Access Compliance Report

Public Rights-of-Way

(Curb Ramps)

Intersection ID: 44304	Main Street: KIEV_DR	Cross Street: MALLORY_TAYLOR_LN	Location: SW
ADA ID: 1D4E71DA200A	Ramp Type: PerpDiag	Initial Pass/Fail: Fail	Overall Compliance: No
			Severity Score: 33.75

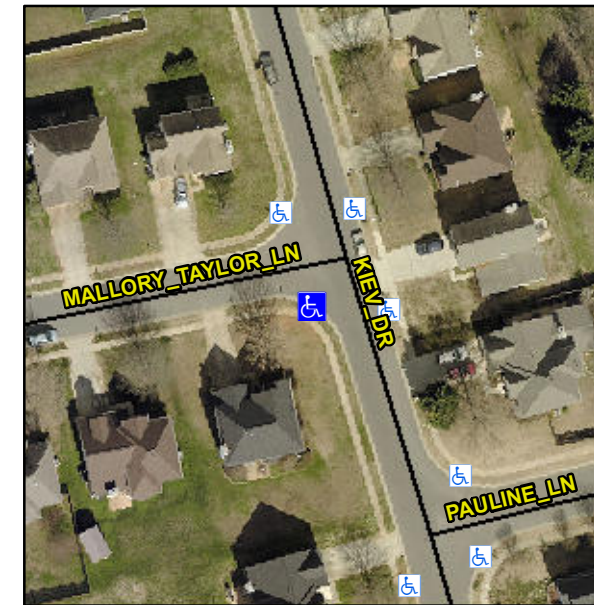
Not Found, R304.5.1, R304.5.3

Compliance	Description	Data	Compliance	Description	Data
N/A	Ramp Length (in)	48.5	Yes	Ramp Slope (%)	7.1
No	Ramp Width (in)	42.0	No	Ramp XSlope (%)	9.8
N/A	Flare Type LT	N/A	N/A	Flare Type RT	N/A
N/A	Flare Slope LT (%)	N/A	N/A	Flare Slope RT (%)	N/A
N/A	Flare Traversable LT?	N/A	N/A	Flare Traversable RT?	N/A
N/A	Landing Length (in)	N/A	N/A	DWS Provided?	N/A
N/A	Landing Width (in)	N/A	N/A	DWS Contrast?	N/A
N/A	Landing Slope (%)	N/A	N/A	DWS Length (in)	N/A
N/A	Landing X Slope (%)	N/A	N/A	DWS Full Width?	N/A
N/A	Landing Curb? (Y/N)	N/A	N/A	DWS Offset (in)	N/A
N/A	Shared Landing?	N/A			
N/A	Gutter Ponding?	N/A	N/A	Gutter Slope (%)	N/A
N/A	Gutter Lip Ht (in)	N/A	N/A	Gutter X Slope (%)	N/A
N/A	Painted X Walk1?	No	N/A	Painted X Walk2?	No
	X Walk 1 Direction	To E		X Walk 2 Direction	To N
N/A	X Walk 1 Width (in)	N/A	N/A	X Walk 2 Width (in)	N/A
	X Walk 1 Slope (%)	3.4		X Walk 2 Slope (%)	2.1
	X Walk 1 X Slope (%)	3.1		X Walk 2 X Slope (%)	3.2

Remove & Replace Curb Ramp With Two New Directional Ramps or Equivalent.
